N O R T H F A L L S

Offshore Wind Farm

Outline Construction Traffic Management Plan (Clean)

Document Reference: 7.16
Volume: 7
Date: July 2025
Revision: 5

Drawing 104560-MMD-00-XX-DR-CE-1032-1_Rev02

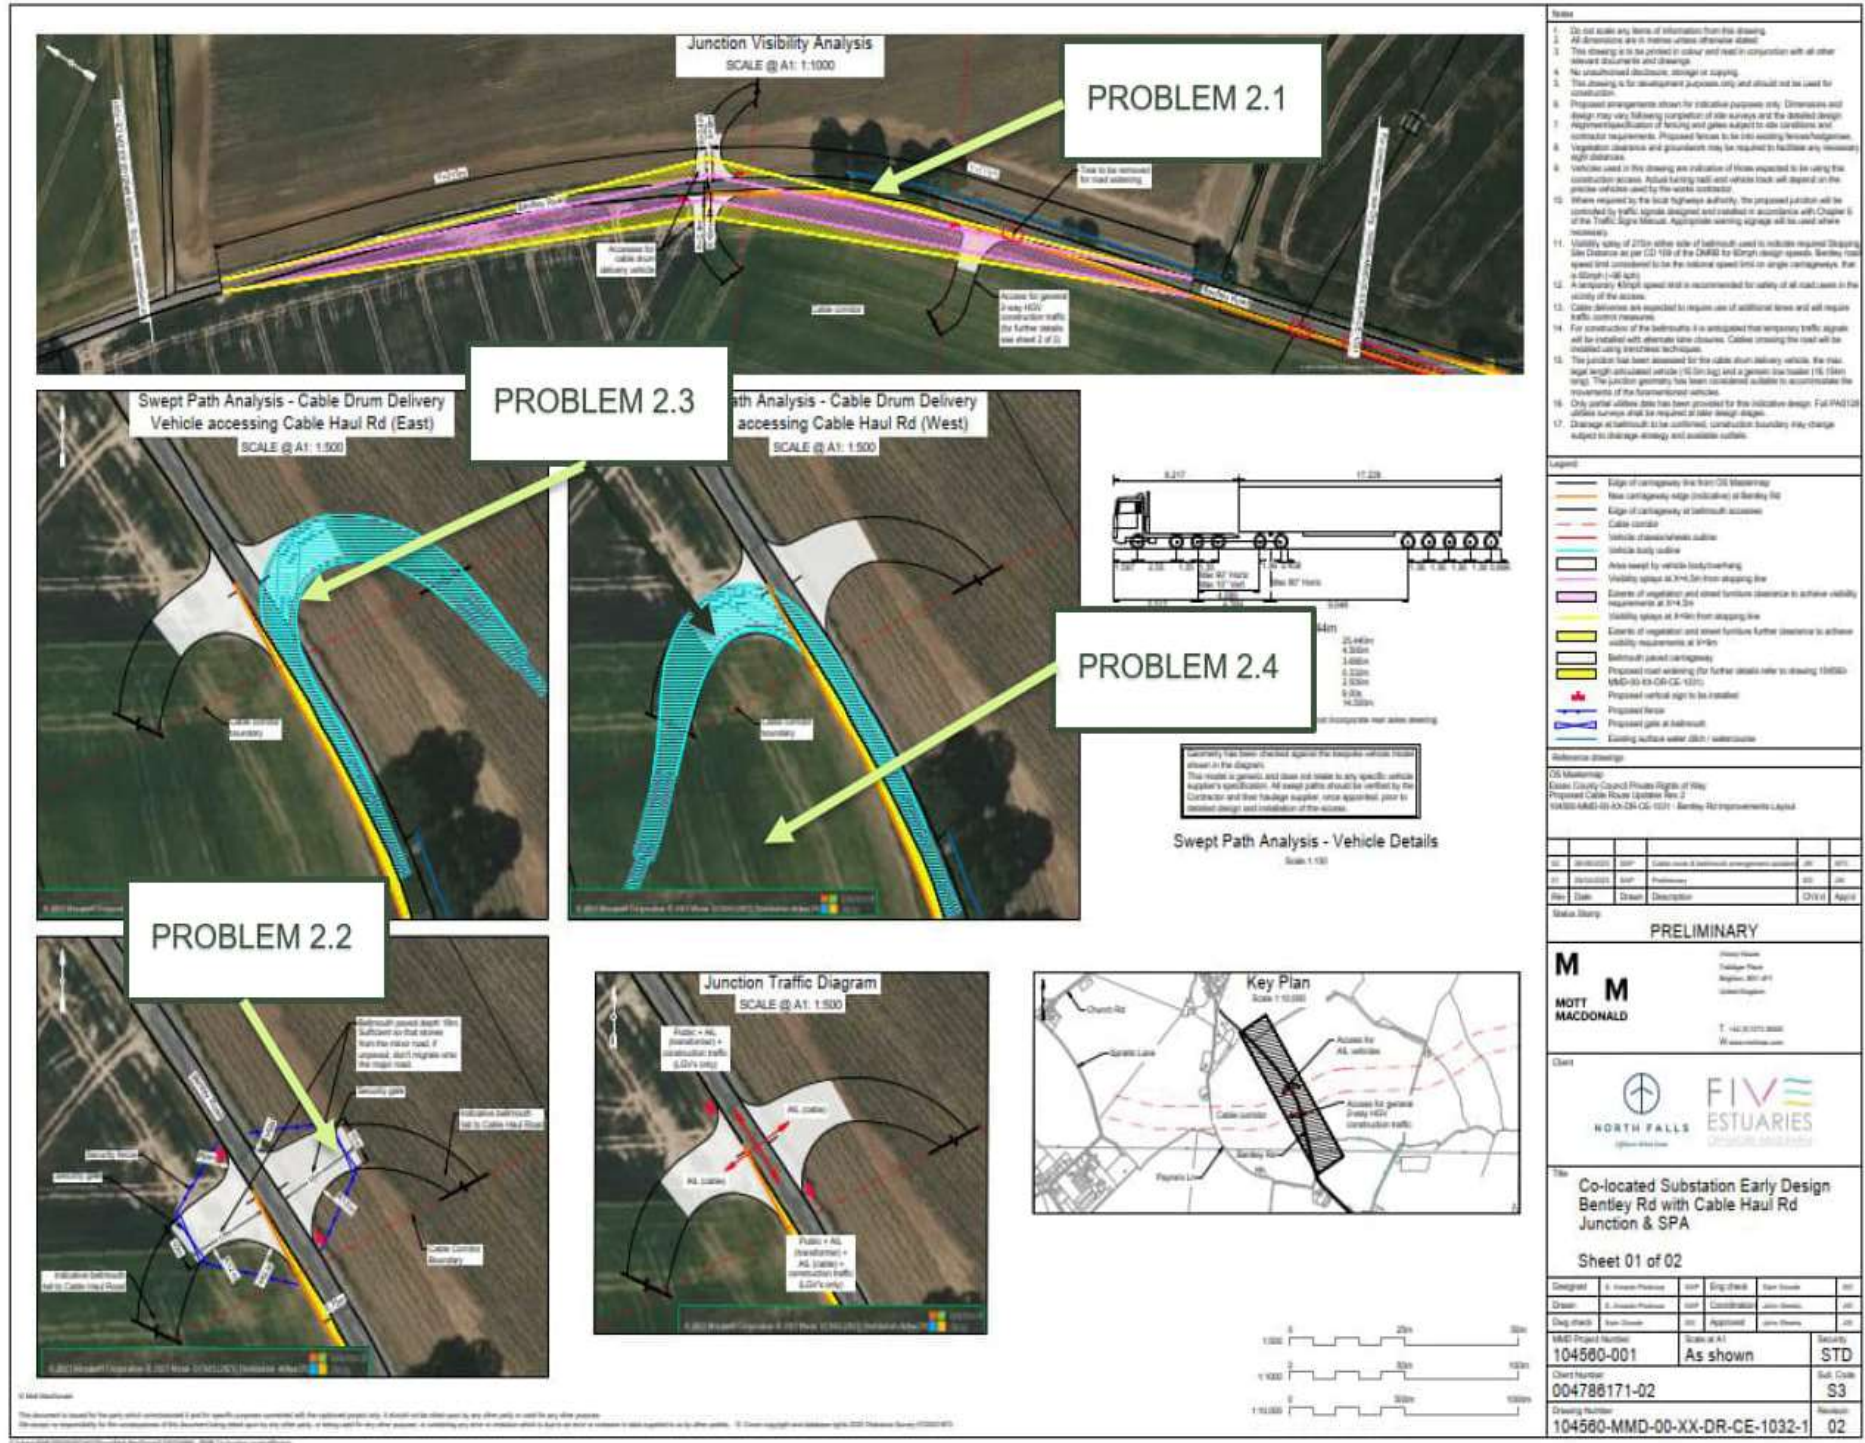
Drawing 104560-MMD-00-XX-DR-CE-1032-1_Rev02						
2.1	Location: Site Access (Temporary Access Junction with Bentley Rd). Refer to Appendix B. Summary: At a 9m setback, existing trees may obscure the visibility splay potentially leading to side swipe type collisions. Onsite observations noted that the presence of existing vegetation may constitute an obstruction to the junction visibility. Obstruction to visibility splays may lead to injudicious vehicle movements at the proposed junction leading to side swipe collisions between vehicles.	It is recommended that the trees be cut back and maintained as such that it does not pose an obstruction to the visibility splays.	● RSA problem and recommendation acknowledged but not agreed since it is not considered that these trees have an impact on the visibility clearance areas. The visibility splay with a 9m setback on the eastern side of Bentley Rd (northern side of Bentley Rd on drawing 104560-MMD-00-XX-DR-CE-1032-1) only captures a small area of road verge west of these existing trees, to run across the road to the other verge side west of Bentley Rd (South of Bentley Rd in drawing 104560-MMD-00-XX-DR-CE-1032-1). Cutting back or trimming the trees will not produce any changes to visibility. Trees are located on the southeast of the road and will cast shadow during most part of the day unless they are totally cut. ● In drawing 104560-MMD-00-XX-DR-CE-1031-3 for the same scheme (refer to Appendix C in this document), it is indicated the trimming of these existing trees to facilitate passage of vehicles, which will also help with general visibility. ● No designer action proposed.	TBC	TBC	No action (TBC).

Drawing 104560-MMD-00-XX-DR-CE-1032-2_Rev01

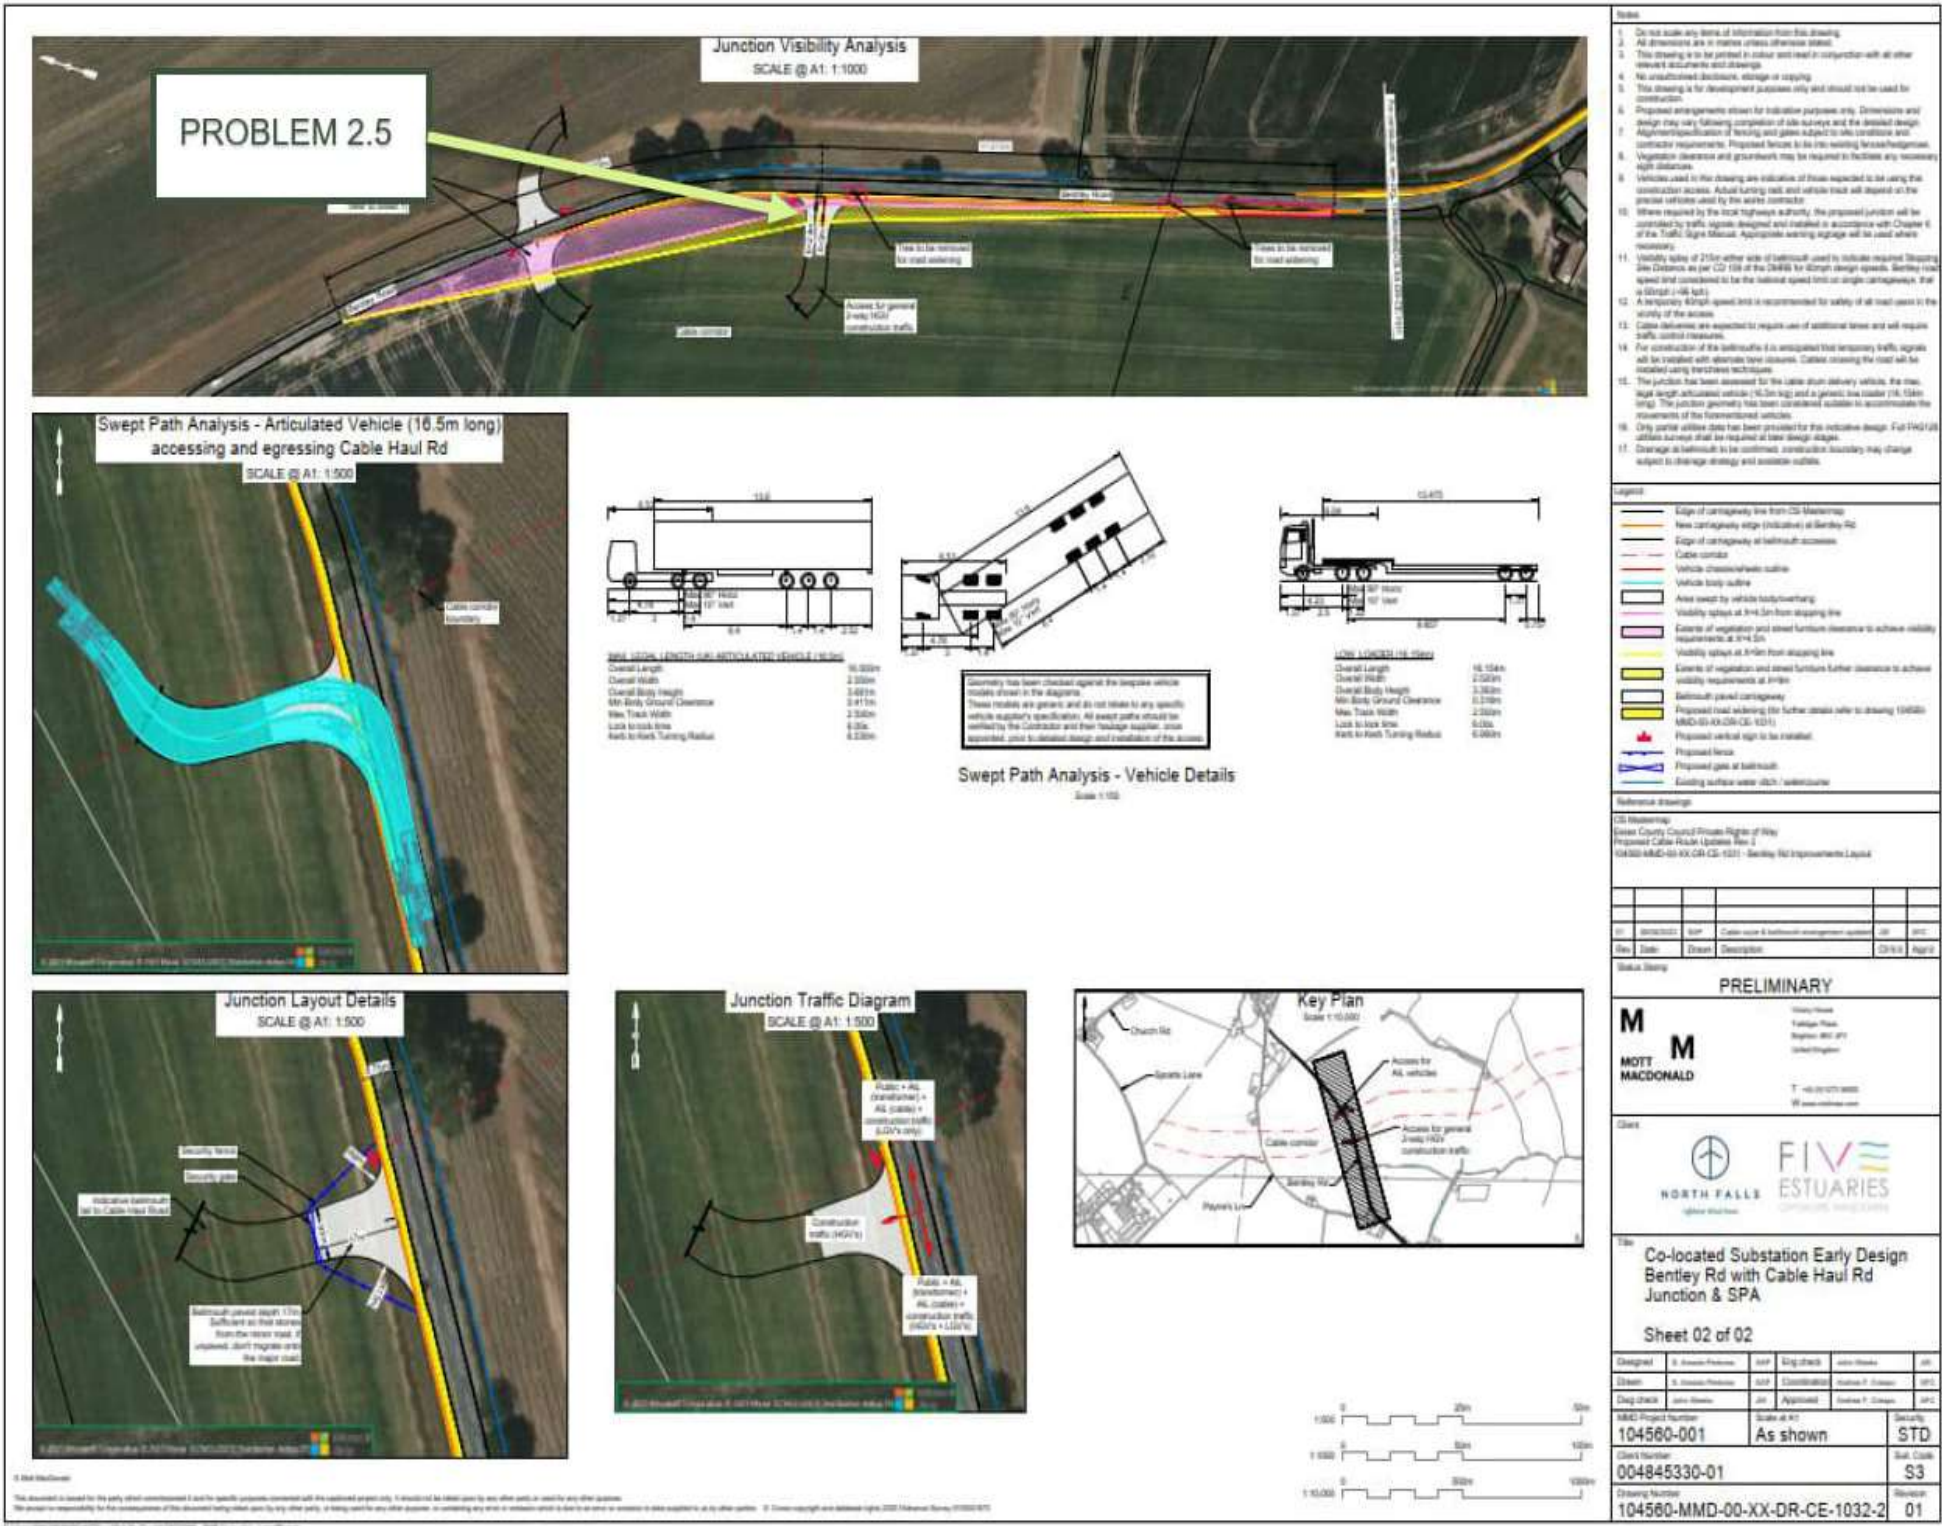
Drawing 104560-MMD-00-XX-DR-CE-1032-2_Rev01						
2.5	Location: Proposed site access. Refer to Appendix B. Summary: The level difference between the carriageway and site could result in loss of control or side swipe type collisions. Onsite observations found that there was a difference in levels between the existing carriageway and the new access. An excessive gradient may create difficulty for large construction vehicles wishing to access Lodge Lane and may in turn lead to a lack of surface friction and slow egress movements potentially creating shunt / side swipe type collisions between egressing construction vehicles and vehicles travelling on Bentley Road.	It is recommended that the existing gradient be amended to an appropriate level for the restart movements of large vehicles accessing Bentley Road from the proposed site	- RSA problem and recommendation agreed. - This matter will be appraised further as an integral part of the detailed design process and drawings developed to take due account of the safety problem and the aligned recommendation.	TBC	TBC	This matter will be appraised further as an integral part of the detailed design process and drawings developed to take due account of the safety problem and the aligned recommendation. (TBC)
